T.I. no.: 2016 - 08 Updated: -	Topic: BU motor, SCA P booster connections, PEEK steam wand
---	--

Date: 28/9/2016	Priority	Need for action
Affected machines: SCA P, SCC, TWIN, E6	High	As soon as possible
From serial number: -	X Medium	X On next visit to the machine
As of date: See entry	Low	FYI only

This technical information applies for SCA P and various coffee machines with the 065006 brewing unit drive motor.

New plug connections on SCA P booster

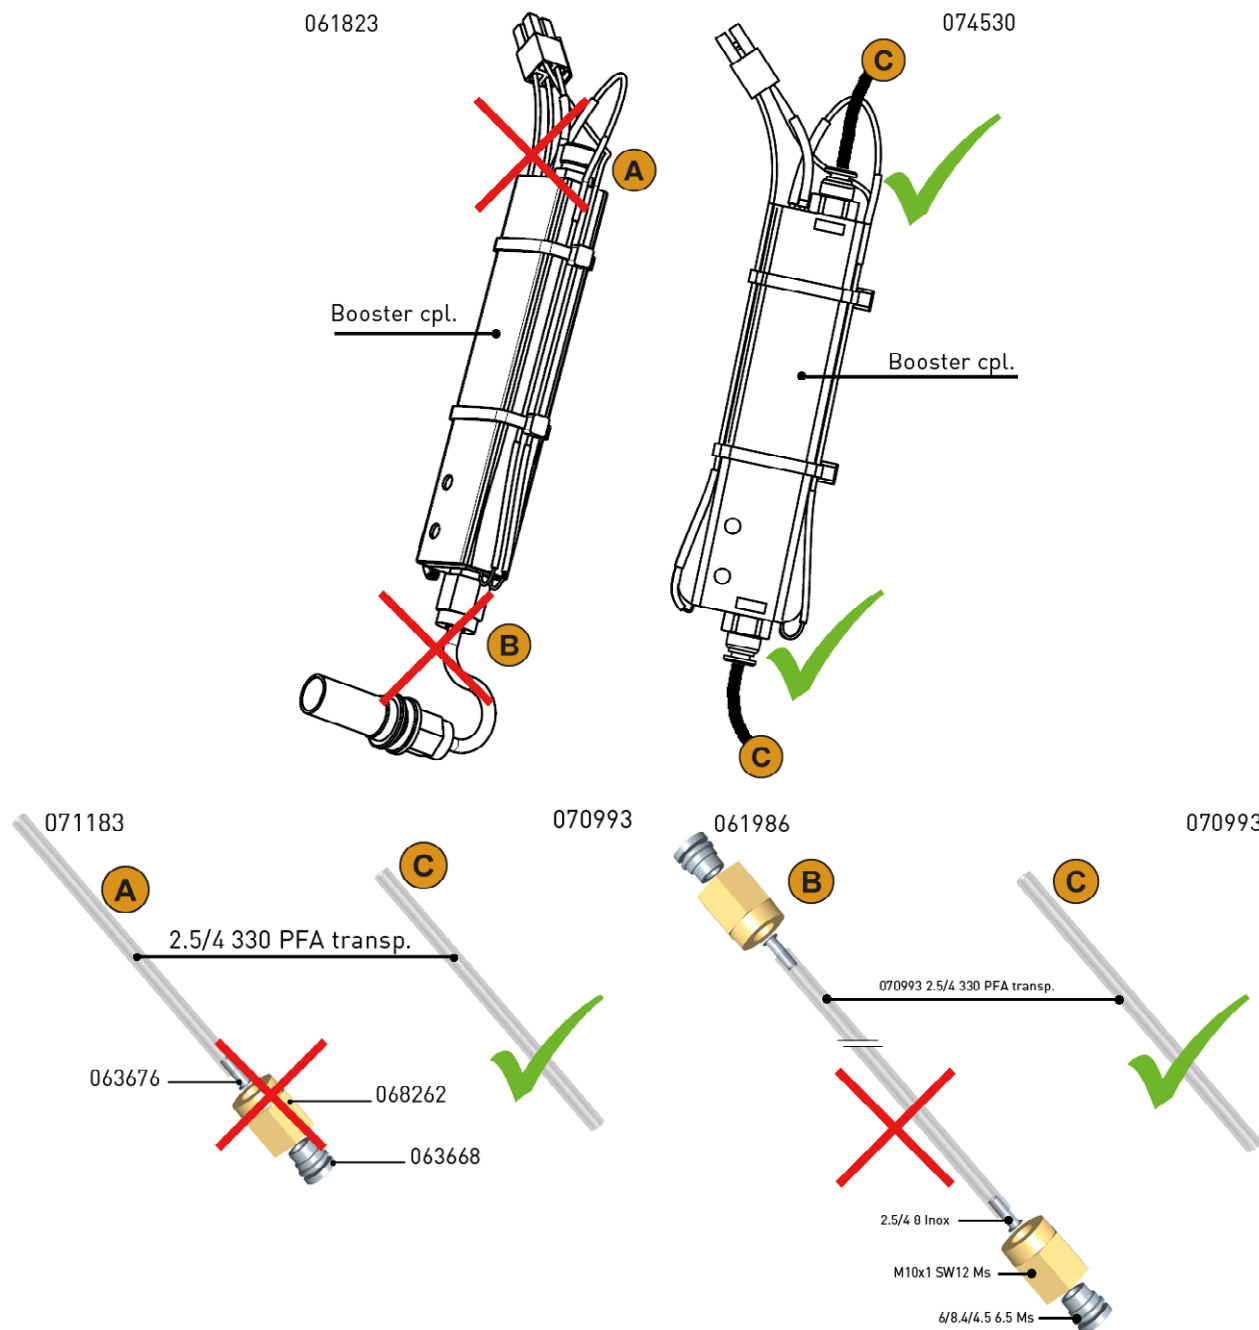
The screw connections on the booster make installing the coffee machine more difficult. From CW29, the booster will have new plug connections. The supply and drainage pipes must be replaced so these new connections can be used.

- Booster 061823 (Index h) will be replaced by 074530 booster
- Pipe 071183 will be replaced by hose 070993 (90 mm)
- Pipe 061986 will be replaced by hose 070993 (330 mm)

New SCA P booster brewing valve connection

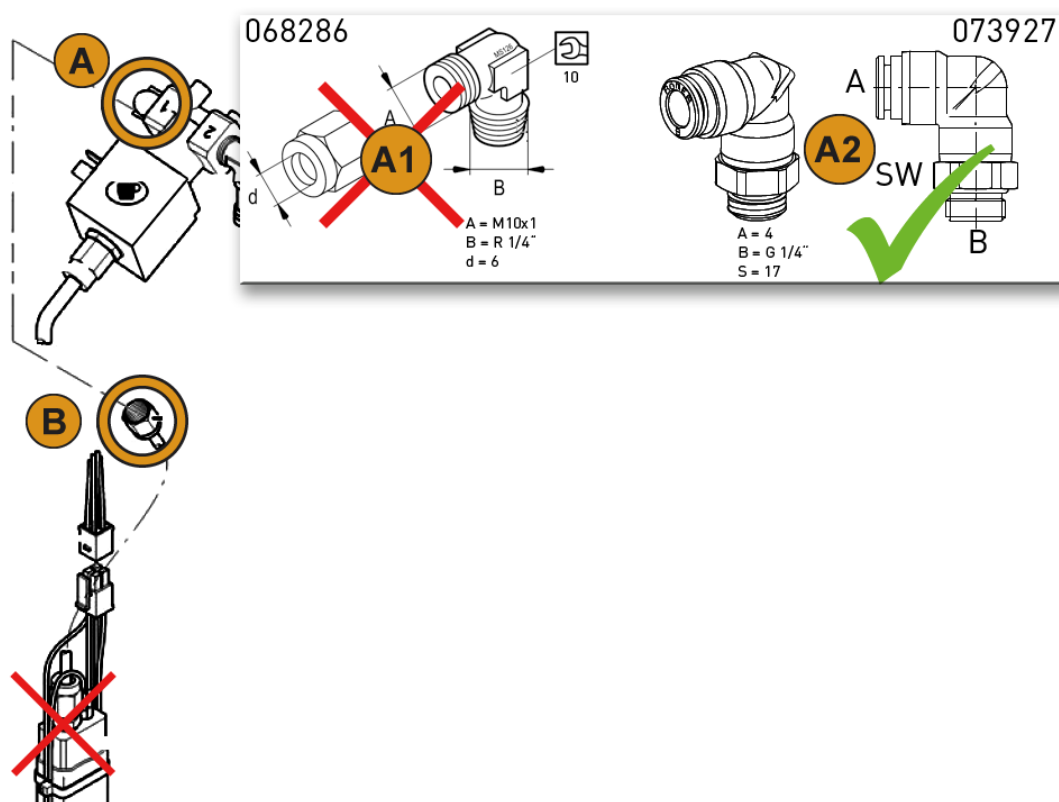
Installing the hose connection from the elbow screw-in fitting (A) to the booster (B) is time-intensive. The hose connection will be replaced by plug connections from CW29. The prerequisite is the new 074530 booster with plug connections.

- Elbow screw fitting 068286 6 M10x1 R1/4" SW 10 Ms will be replaced by elbow screw fitting 073927 4 G1/4 SW17 (Römer 930-P3-4FF-1/4)

New scale on the brewing unit drive motor (SCA P, SCC, TWIN and E6)

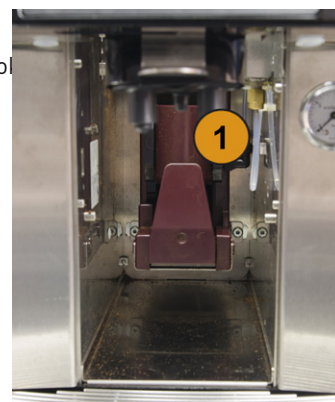
The driver (C) is turned by 1/8 rotations compared to the brewing unit after 30,000 lifting movements so that drive motor 065006 (Index b) is uniformly loaded (motor angle of rotation). The prerequisite is that mark [A] is set to [1] when installing the drive motor. The scale will be available on the drive motor from CW35. The lifting movement counter must be checked during every maintenance process. If applicable, the driver must be adjusted.

- ▶ Switch on the machine and let the brewing unit initialise 1 time.
- ▶ Switch the machine off.
- ▶ Set marking [A] to (1) on the motor with a water-resistant felt-tip marker.

- ▶ Check counter status for the number of lifting movements.
- ▶ After 30,000 lifting movements, rotate the brewing unit.
- ▶ Move brewing unit into home position (reset machine, e.g. by restarting it).
- ▶ Remove the brewing unit from of the machine.
- ▶ Turn driver (C) 1/8 rotations until mark [A] is at the next numbering (B).
- ▶ Reinsert the brewing unit in home position.
- ▶ Enter adjustment, including the last counter status, in the machine's maintenance book
